**CLEANUP OR ABATEMENT ORDER – GENERAL CONSTRUCTION STORM WATER PERMIT; GOLDIE LANE PROPERTY; SANTA MARGARITA; SAN LUIS OBISPO COUNTY; WDID# 3 40S319357**

**CLEANUP OR ABATEMENT ORDER NO. R3-2003-0021  
Issued to David Pierson**

**GENERAL CONSTRUCTION STORM WATER PERMIT: DAVID PIERSON, GOLDIE LANE  
PROPERTY, SANTA MARGARITA, SAN LUIS OBISPO COUNTY  
WDID# 3 40S319357**

Photo 1 – Gully erosion on cleared hillsides, no erosion or sediment control.

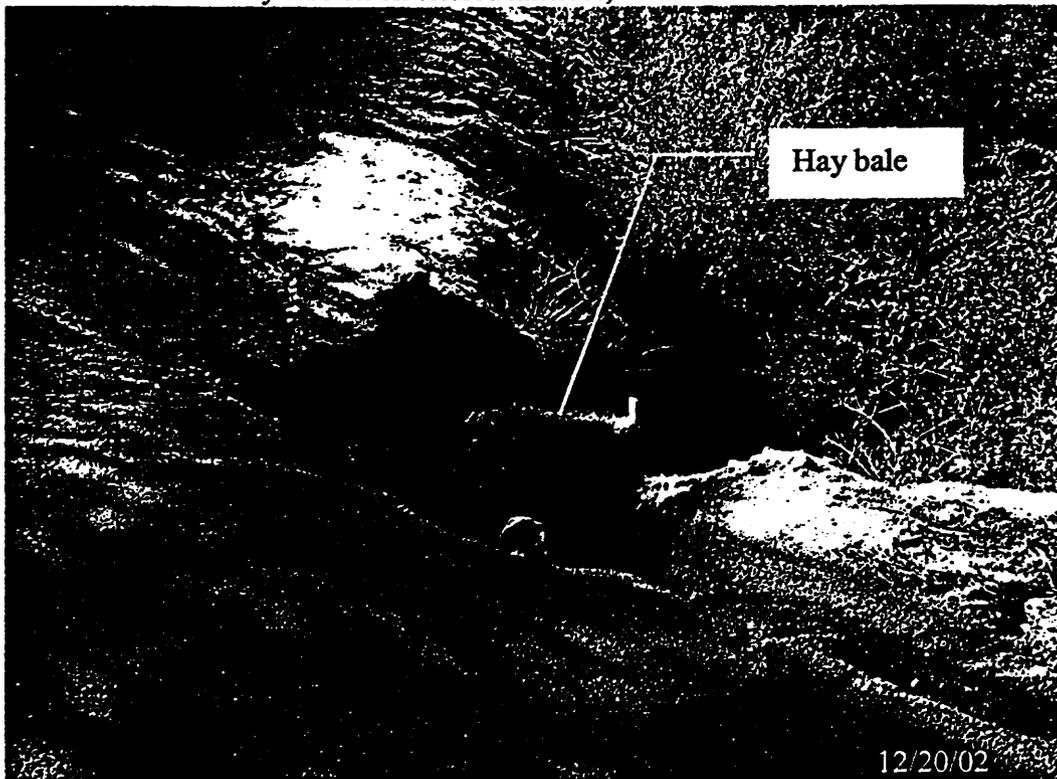
2. On November 8, 2002, and December 20, 2002, Regional Board staff inspected the Site and found it in violation of the General Permit. Regional Board staff observed widespread erosion of the cleared hillsides and the access road that transverses the property (Attachment A, Photos 1, 2). The erosion of the access road has resulted in sediment discharging to the unnamed blue line creek tributary to the Huerhuero Creek. The discharge of sediment-laden water could have been eliminated or minimized with the use of Best Management Practices (BMPs). The discharge of sediment to the creek is a violation of the General Permit Discharge Prohibition A.2.

- c. **By January 31, 2003**, David Pierson shall prevent erosion by covering all inactive disturbed slopes, and stockpiles at the site with effective erosion control BMPs. The erosion control BMPs may include bonded fiber matrix, blankets, mulch, straw, or other means that prevent erosion.

Photo 2 – Erosion from road cutting around hay bale.

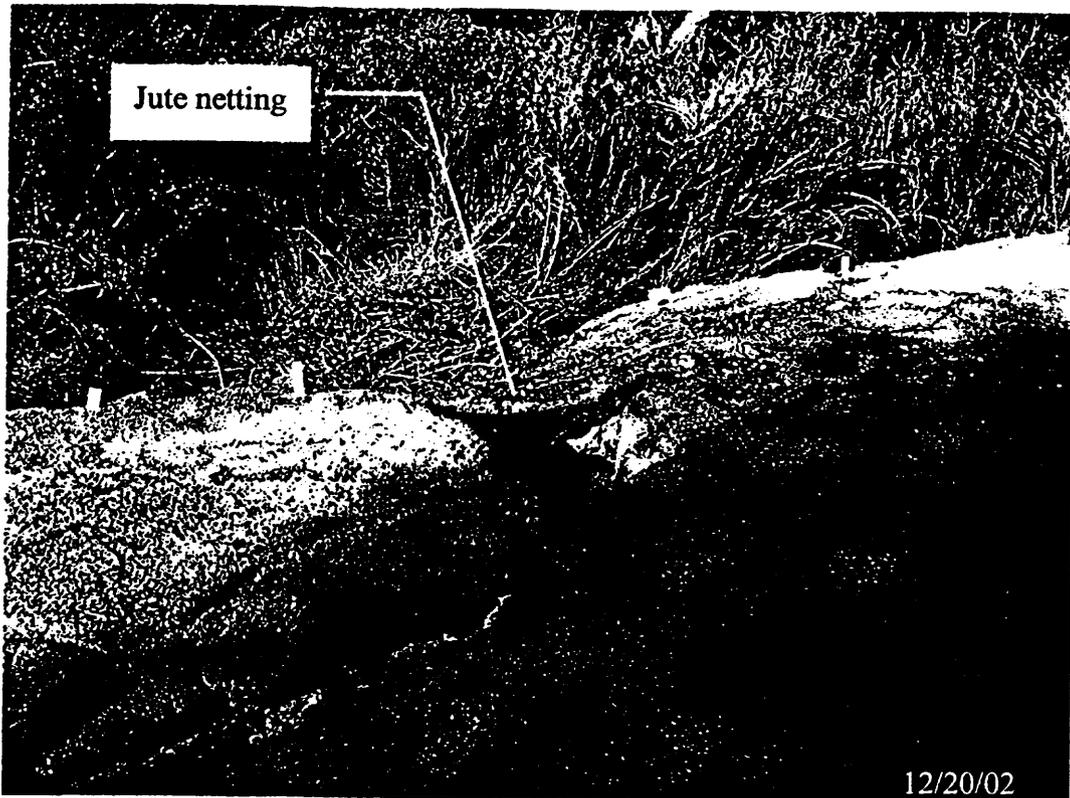
netting, were overwhelmed without erosion control measures for the road (Attachment A, Photos 2, 3). Some sections of the road had neither erosion nor sediment controls (Attachment A, Photo 4). David Pierson has failed to implement an effective combination of erosion and sediment control as required by Section A.6 of the General Permit.

- d. **By January 31, 2003**, David Pierson shall stabilize all access roads on Site to prevent further erosion of the road surfaces.
